# Strategic Environmental Assessment (SEA) of the Proposed Amendments to

## North Lotts and Grand Canal Dock Planning Scheme 2014

**Prepared by  
Planning and Economic Development Department  
Dublin City Council  
May 2019**

## 1.5. Proposed Amendments to North Lotts and Grand Canal Dock Planning Scheme

Fig 35 - Development Code For City Blocks

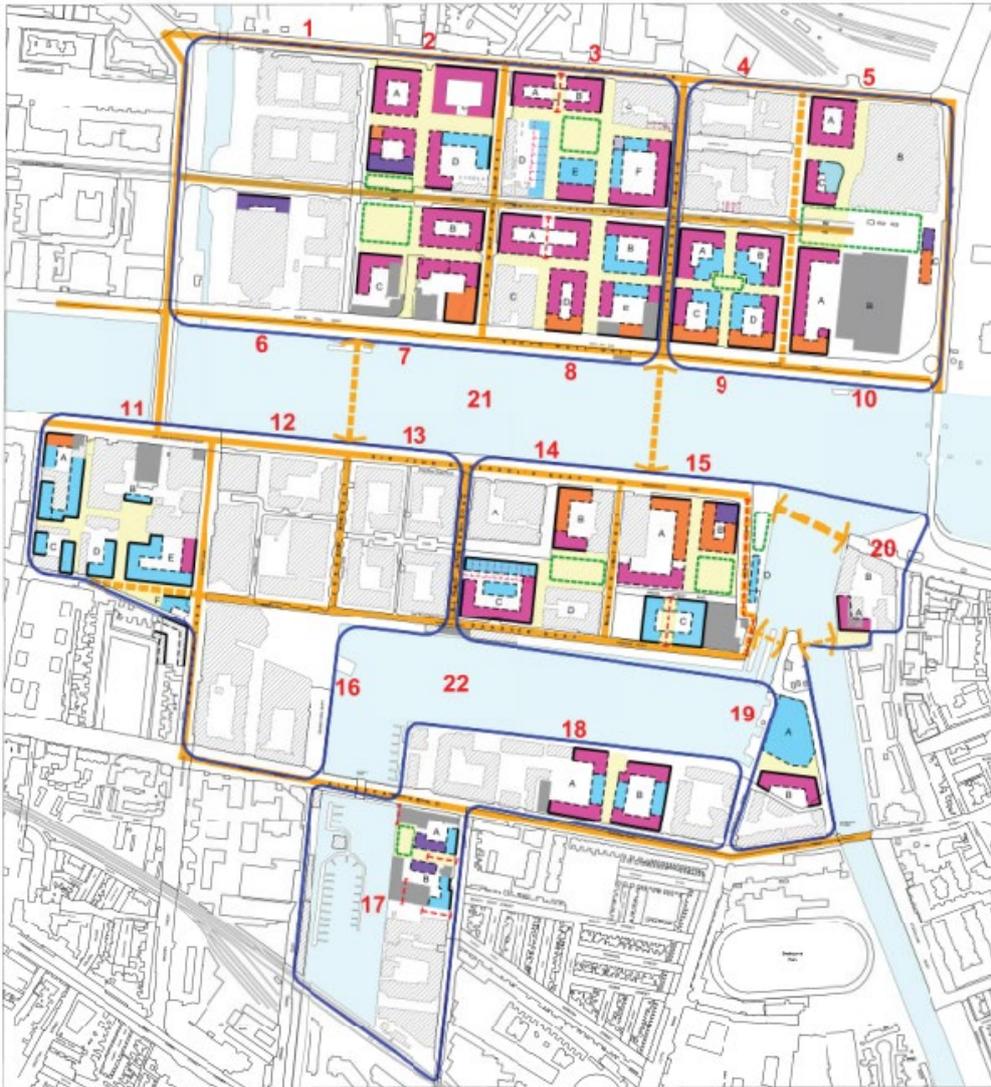
The North Lotts and Grand Canal Dock SDZ Planning Scheme contains development codes for height standards in Figure 35. The amendment now seek to revise the following heights standards having regards to the criteria set out in the heights' guidelines

- (a) Text providing for additional Storey supporting Figure 35 and compliance with heights guidelines
- (b) Amend urban form/heights in City Blocks 2, 3,7, 9, 11, 18 and 19
- (c) Amend Figure 35 Graphic

Page 174. Last sentence to be amended, i.e. “In addition to the setbacks which may be necessary for design and amenity reasons within the height envelope in Fig. 35, an additional storey, with a setback of 1.5m plus may be considered subject to a shadow analysis and a compelling urban design rationale. ~~This option for additional storey shall not apply to Blocks 1 to 5~~ This provision does not apply to any landmark or local landmark buildings

### City Block 2

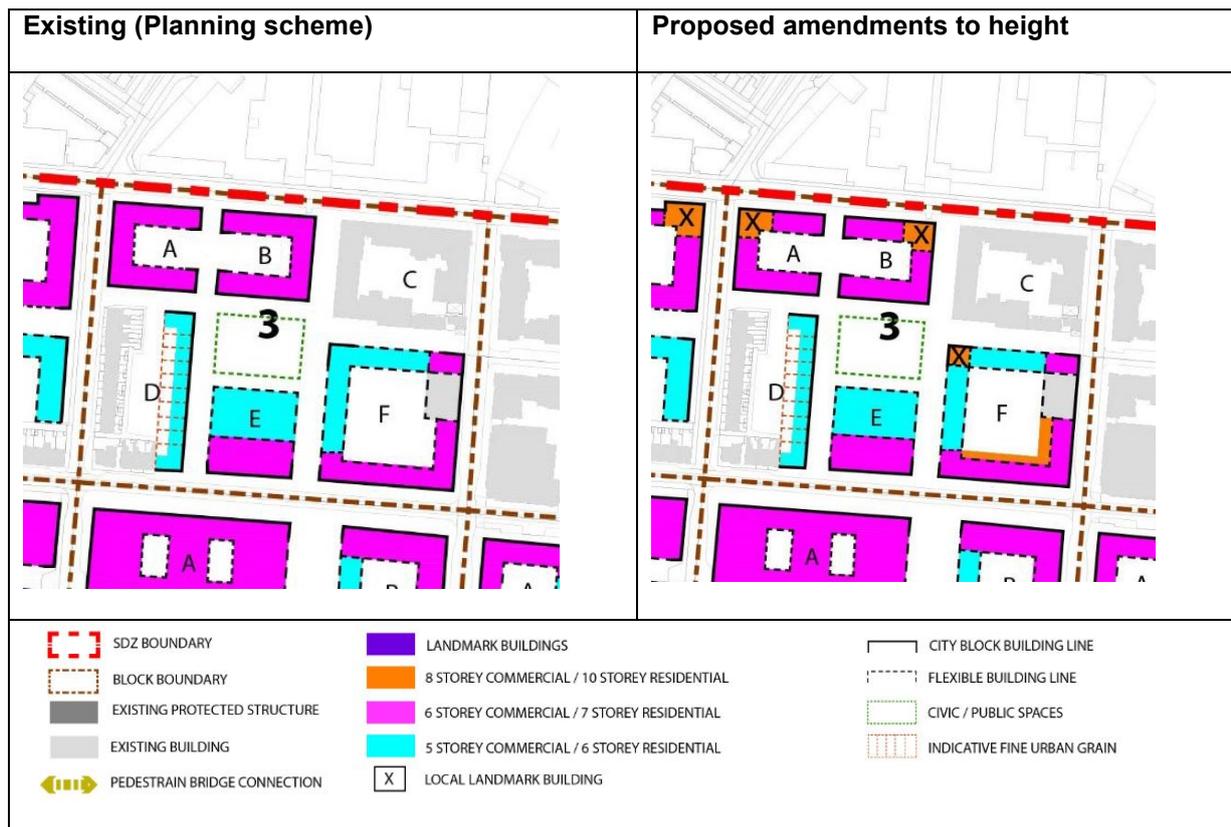
Page 183 Section 5.5.2, 2, ‘Urban Form/Height Range’ to be amended .i.e.

- Block 2A to be 8 Storey commercial/10 storey residential fronting onto Sheriff Street Upper.
- 12 Storey residential local landmarks at NE and NW corners of block 2B, to extend along no more than one third of the sub-block frontages.
- Block 2C to be 12 storey (maximum) commercial (minimum 10 storey) fronting Station Square, to achieve balance between hub quantum and view lines from Georgian mile. Landscaped plaza south of block. Western side of 2C to be 8 storey commercial/10 storey residential.

- Remaining blocks to range between 5 storey commercial/6 storey residential and 6 storey commercial/7 storey residential, stepping down to 3 residential immediately north and west of the Mayor Street terrace.
- Urban blocks to front Sheriff Street to remake and contain the street.
- The 7 storey residential frontage to New Wapping Street responds to the 2/3 storey terrace opposite, more favourably than the 9 storey scheme previously certified.

• ~~Any temporary pavilion buildings to be up to a maximum of 4 storeys~~

### City Block 7

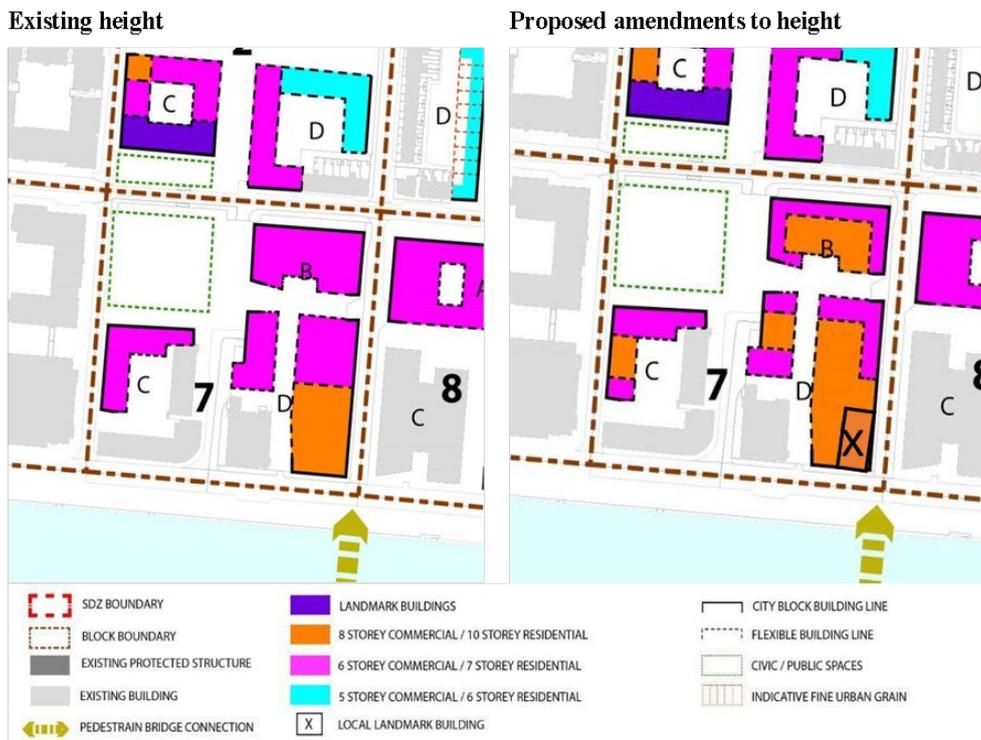
Page 190 Section 5.5.7, Urban Form/Height to be amended .i.e.

- ~~6 Storey commercial/ 7 storey residential in blocks 7C and D to provide balanced context for the Protected Structures and central Station Square.~~

- 7 Storey commercial to block 7B fronting Station Square, reducing to 6 storeys commercial (7 residential) to east, having regard to balance between economic hub and residential amenity for terrace north of Mayor Street. **To include 8 storey commercial/ 10 storey residential setback from Mayor Street Upper frontage. The additional storeys to sit below a 35 to 45 degree inclined plane from the main parapets fronting all streets and spaces.**

- 8 storey commercial /10 storey residential element set within the central section of the western side of 7C – (comprising up to 40% of the total frontage)**

- ~~6 storey commercial/7 storey residential in Block 7D raising to 8 storey commercial to North Wall Quay with appropriate transition to the Protected Structure, the former London and North Western Hotel.~~

- 8 storey commercial /10 storey residential on Block 7D, reducing to 6 storey commercial/7 residential on northern frontages, part eastern frontage on New Wapping Street and north of the protected structure ( former London and North Western Hotel)**

- 12 Storey commercial/ 15 storey residential local landmark at corner of New Wapping Street and North Wall Quay, not to exceed 40m x 25m in area (25m along North Wall Quay and 40m along New Wapping Street).
- ~~Any temporary pavilion buildings to be up to a maximum of 4 storeys~~

### City Block 9

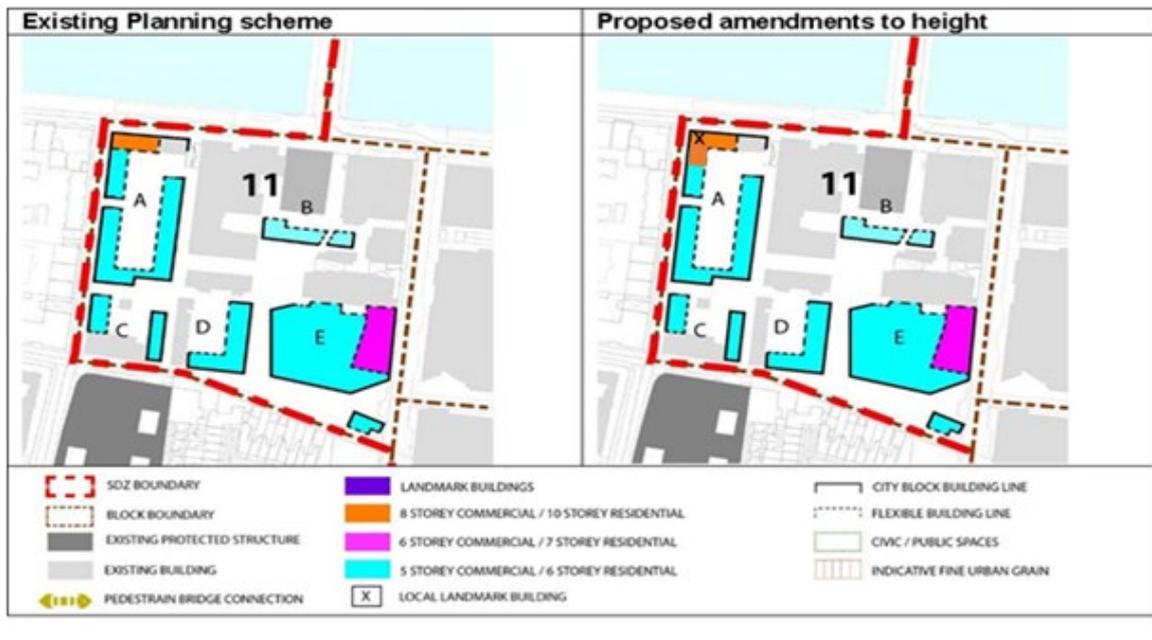
Page 194 Section 5.5.9, Urban Form/Height to be amended .i.e.

- Building heights to range from 5 storey commercial (6 storey residential) to 8 storey commercial (10 storey residential) to allow for residential amenity and appropriate transition in scale, as well as sufficient enclosure onto main streets, and appropriate scale fronting Quays.
- 12 Storey residential local landmark at the north east corner of 9B to extend not more than 30% of the frontage to Mayor Street upper and 25% of frontage along North Wall Avenue.
- A 22-25 storey Liffey Gateway residential tower at the south-east corner of block 9D not exceeding 25m x 30m per floor.

### City Block 18

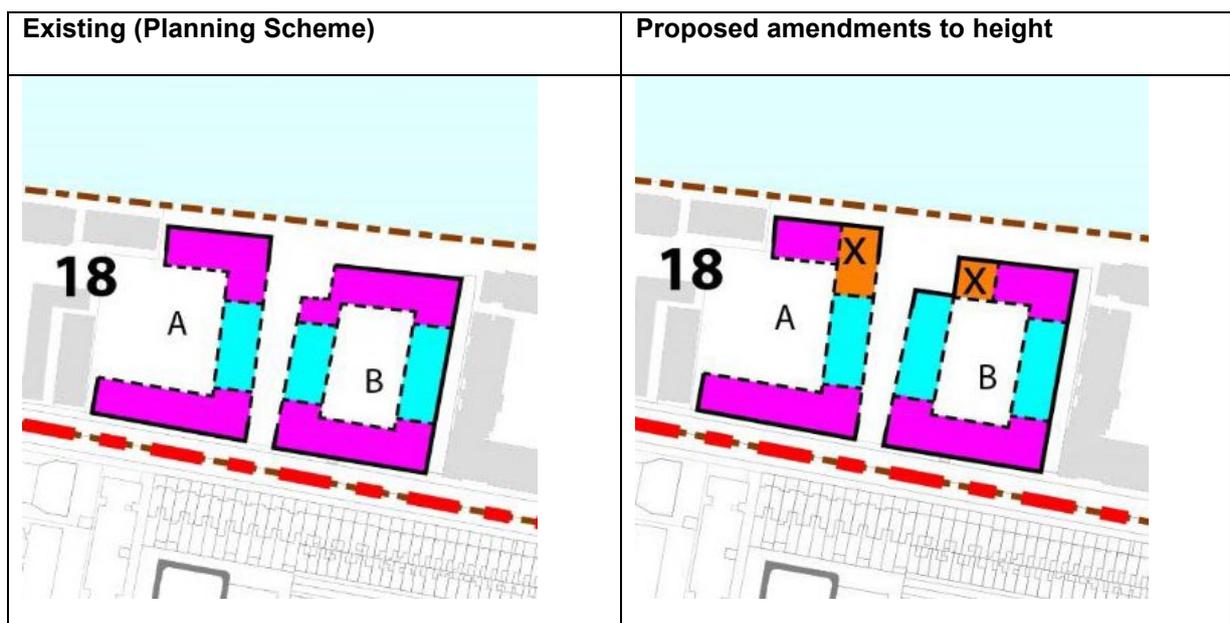
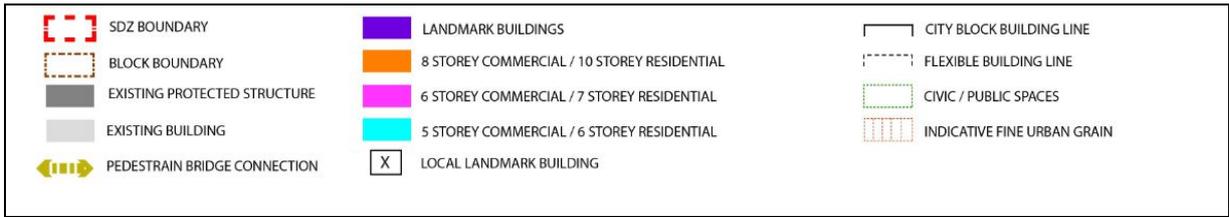
Page 211 Section 5.5.18, Urban Form/Height to be amended .i.e.

- 6 storey commercial / 7 storey residential along the water frontage to frame Grand Canal Dock and also along Ringsend Road to define the streetscape.
- **10 Storey residential local landmarks at corners of 18A and 18B, must extend for no more than one third of the length of the sub-block frontages.**

**City Block 19**

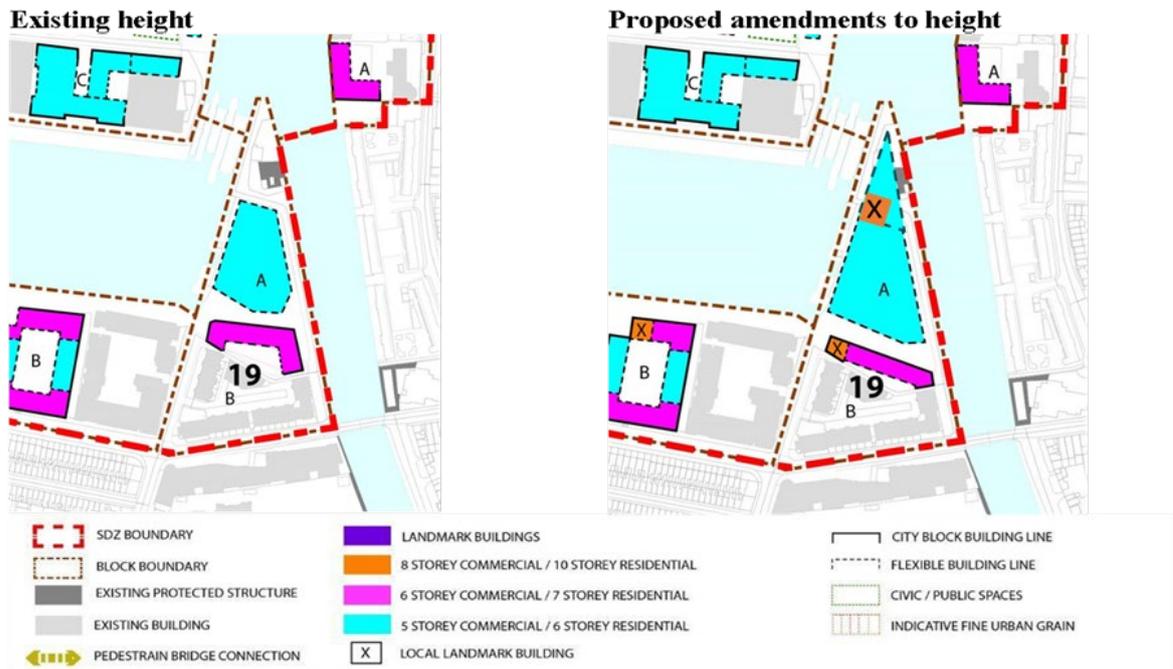
Page 213 Section 5.5.19, Urban Form/Height to be amended .i.e.

- Commercial / community buildings up to 5 storeys to contain the dock space. Residential perimeter block up to a maximum of 7 storeys to northern side of existing Camden Lock Development, subject to an appropriate transition in scale and design criteria which protects the residential amenity and minimises overshadowing of the Camden Lock Development.
- 8 Storey commercial/10 storey residential local landmark to north of Block A**
- 8 storey commercial/ 10 Storey residential local landmark at the western end of 19B, must extend no more than one third of the length of the sub-block frontage.**
